## LINCOLN CITY/LANCASTER COUNTY PLANNING STAFF REPORT

**P.A.S.:** Stone Ridge Estates **DATE:** November 14, 2001  
Change of Zone #3330 (AG to R-3)  
Preliminary Plat #01010  
Special Permit #1946

**PROPOSAL:** Change of Zone #3330 Changes the zoning on 117.03 acres northwest of the intersection of South 27<sup>th</sup> Street and Yankee Hill Road from AG to R-3.

**SHEET**  
**1 OF 12**

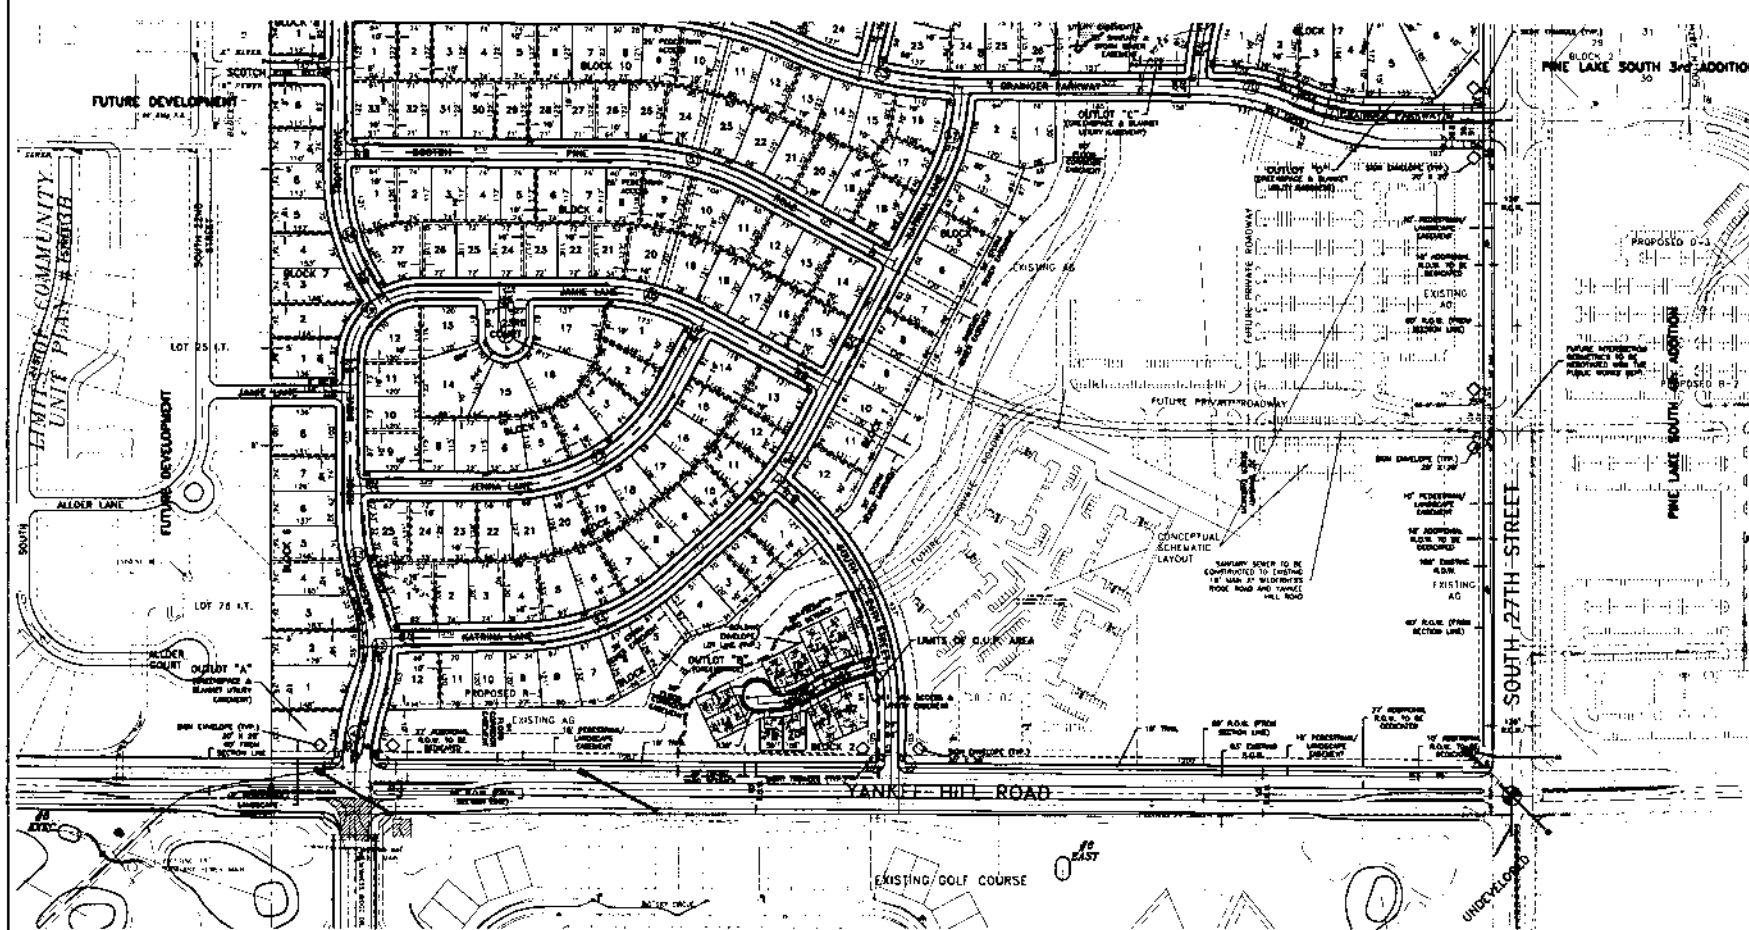
6. Yankee Hill Road is a Public Way Corridor, and as a result a 120' wide right-of-way is required, except within 1,000' of intersections like South 27<sup>th</sup> Street and Yankee Hill Road where it widens out to 130'. This plat is dedicating the additional right-of-way to provide the required north 60', but because Wilderness Ridge south of Yankee Hill Road was platted prior to this requirement, only 50' of right-of-way was dedicated on the south side. Because the typical 120'-130' section will never be built in this area, the cross-section detail on the plat must be revised to reflect the correct right-of-way width.

1. After the subdivider completes the following instructions and submits the documents and plans to the Planning Department office, the preliminary plat will be scheduled on the City Council's agenda: (NOTE: These documents and plans are required by ordinance or design standards.)
  - 1.1 Revise the preliminary plat to show:
    - 1.1.1 A corrected legal description for the CUP.
    - 1.1.2 Match the boundaries for the limits of the plat and CUP to the legend for Sheets 1 and 2.

- 1.1.3 A corrected typical cross-section for public way corridors on Sheet 1.
- 1.1.4 Match the limits for the CUP on Sheets 1 and 2.
- 1.1.5 Expansion of Outlot D north of Grainger Parkway adjacent to Lots 2-6, Block 17.
